HISTORIC AND DESIGN REVIEW COMMISSION

Agenda Item No: 34

HDRC CASE NO: 2016-255
ADDRESS: 431 QUEENS CRESCENT
LEGAL DESCRIPTION: NCB 3089 BLK 5 LOT E IRR 120 FT OF 9 & E TRI 1 FT OF S 70 FT OF 10
ZONING: MF33 H
CITY COUNCIL DIST.: 1
DISTRICT: Monte Vista Historic District
APPLICANT: Robert Murray, AIA
OWNER: Pursuant Ventures Development, LLC
TYPE OF WORK: Carport, Driveway, Front Entrance modification, Addition
REQUEST:

**Historic and Design Review Commission
Design Review Committee
Report & Recommendation**

3 PROPOSED SOUTH ELEVATION
SCALE 1/4" = 1'-0"

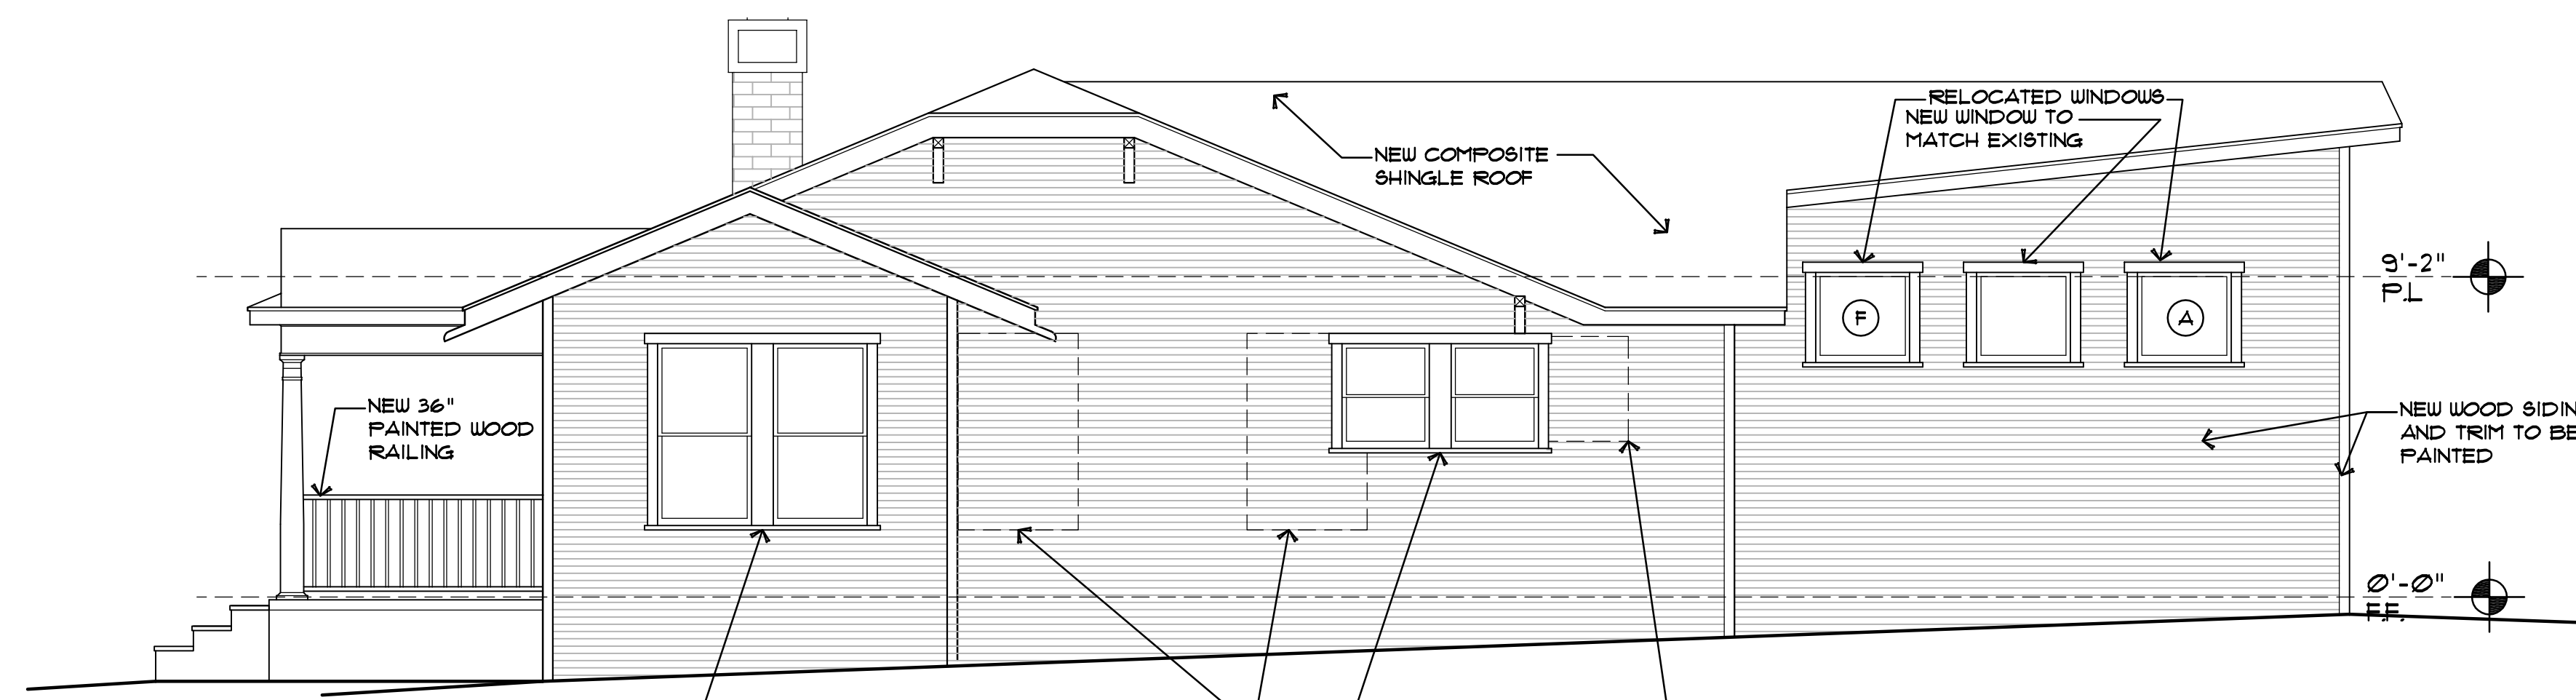
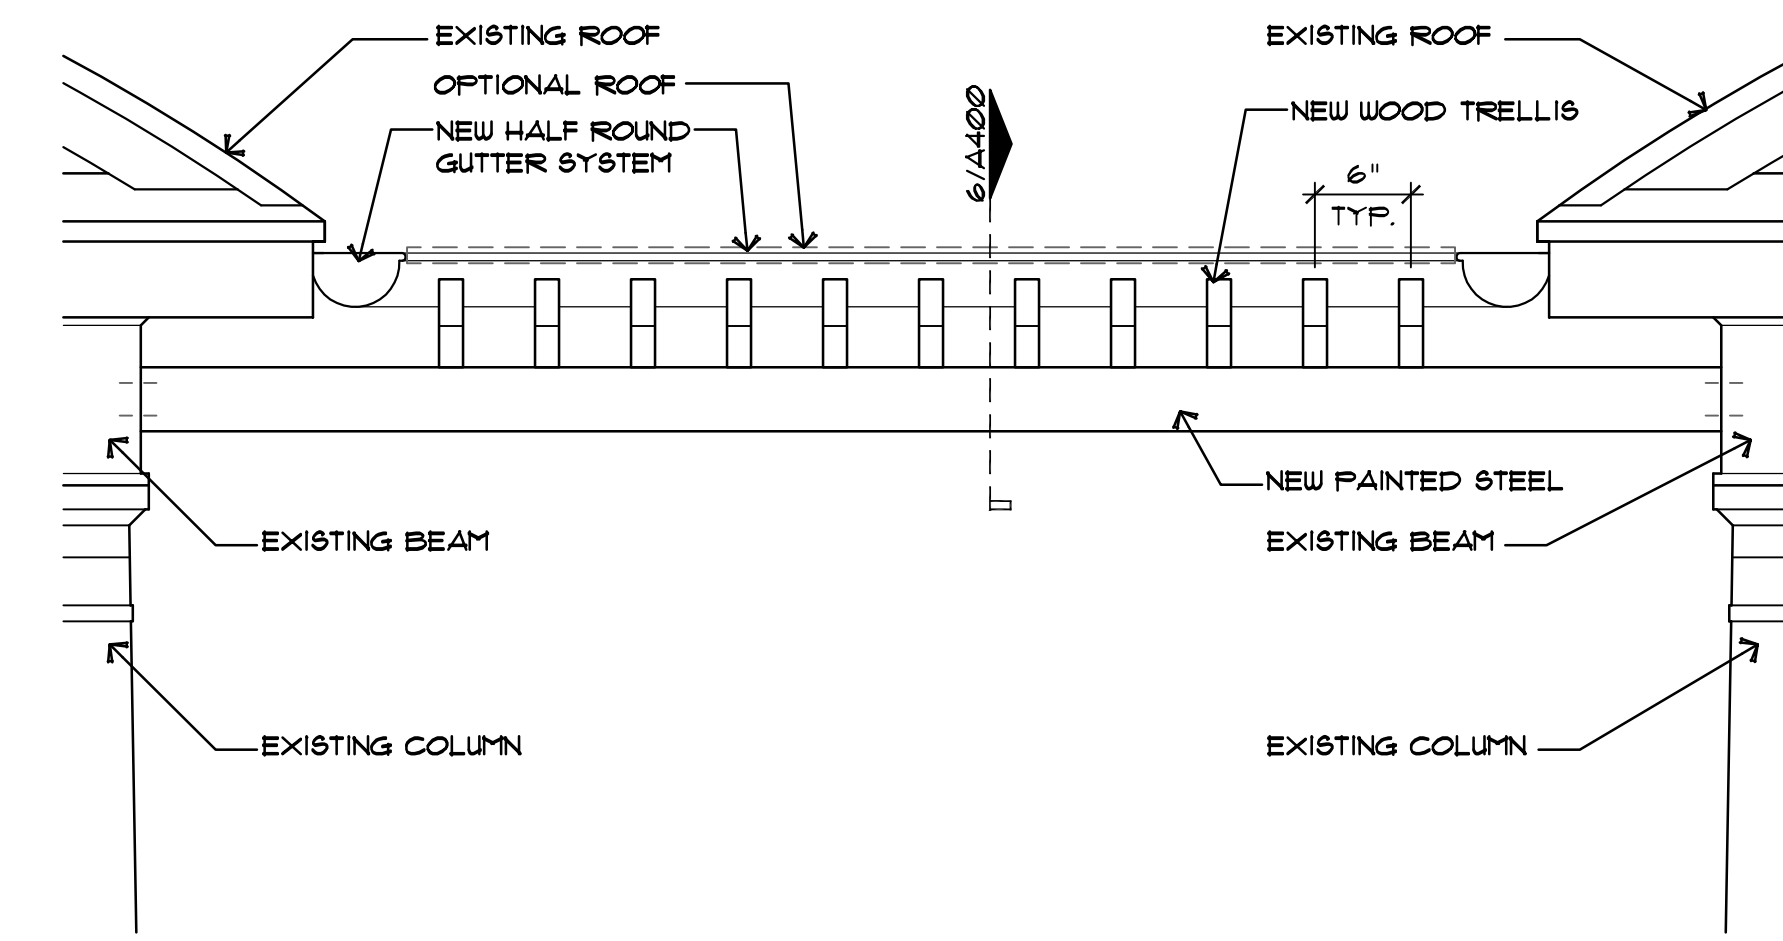
- s. WINDOW OPENINGS - The applicant is proposing to remove two doors and two windows, and alter two windows on the rear elevation, remove one window on the south elevation, and alter 3 window openings on the north elevation. According to the Guidelines for Exterior Maintenance and Alterations 6.B.i, window and door openings should be preserved. Staff finds the removal of the windows where the addition to be located appropriate, but finds the removal of the two door and altering of the window openings not consistent with the Guidelines. Staff recommends that the existing window and door openings be preserved.

Staff recommends denial of item #7 based on finding s.

5 FRONT ELEVATION ENLARGED
SCALE 1" = 1'-0"

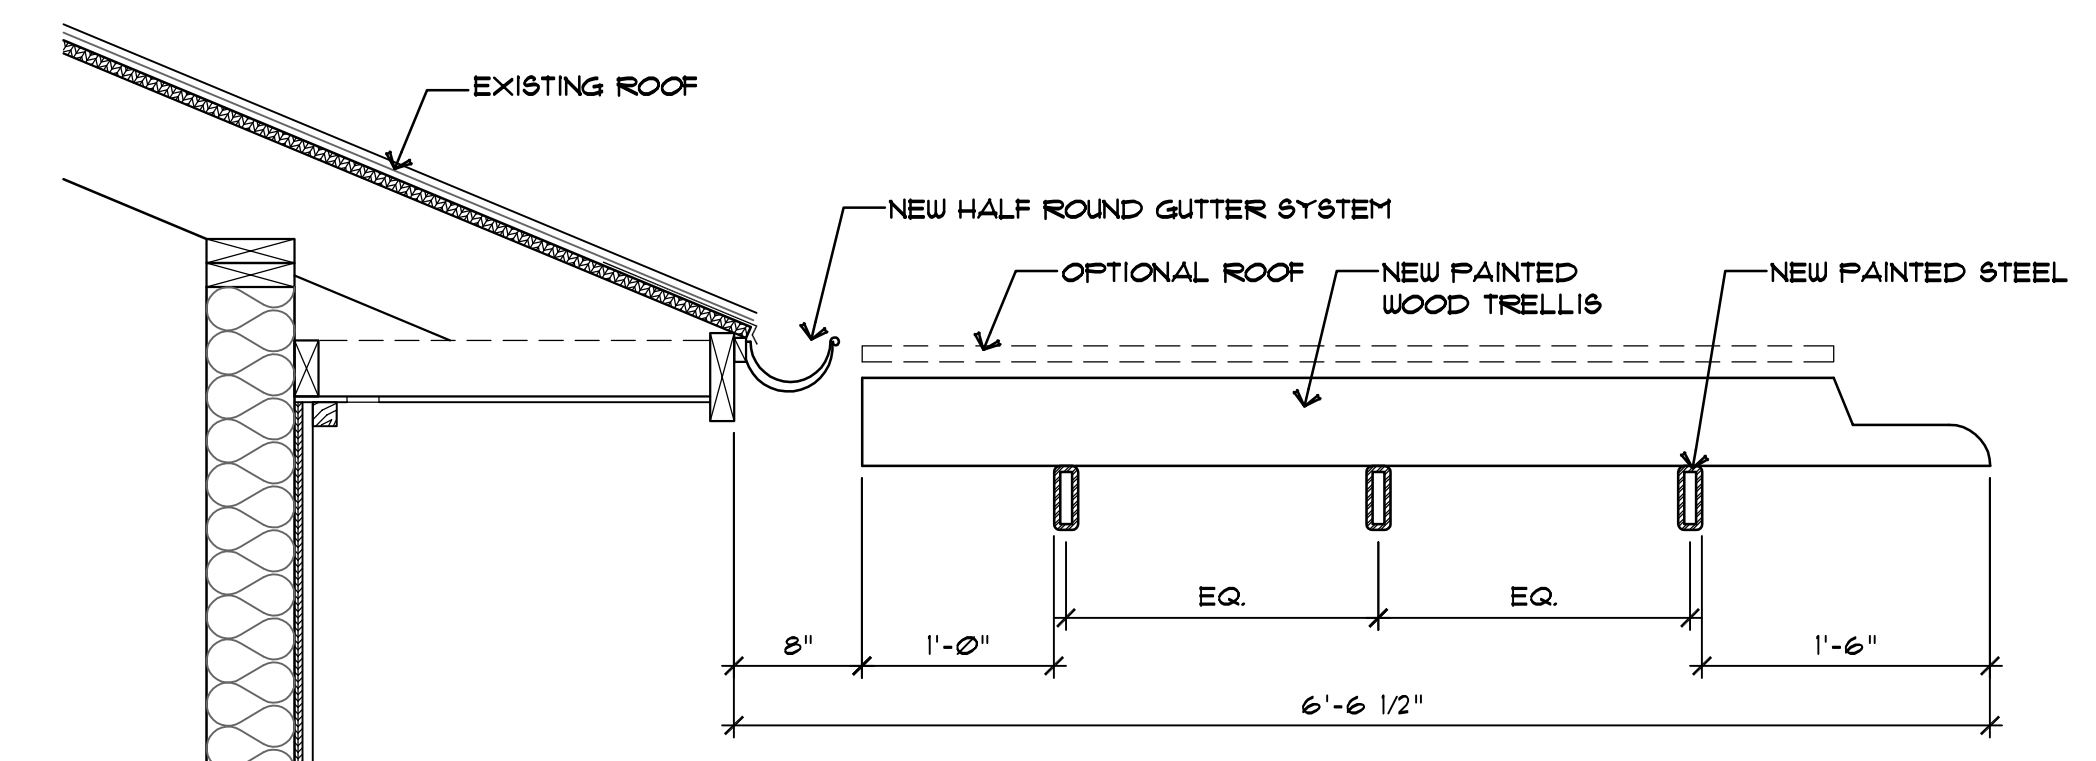
- j. **FRONT PORCH** – Additionally, the applicant is proposing to connect the two existing concrete porches and create one long porch with wood decking, steel and wood trellis connecting the arches, and installing 36” decorative wood railing around the porch. The four round columns will remain and connected with simple railing where needed. According to the Guidelines for Exterior Maintenance and Alteration 7.B., design replacement elements to be simple and to not distract from the historic character of the building. Staff finds the proposed design of the trellis simple and appropriate for the architectural style of the building, therefore is consistent with the Guidelines.

BF: Railing without circle/detail, simpler design.
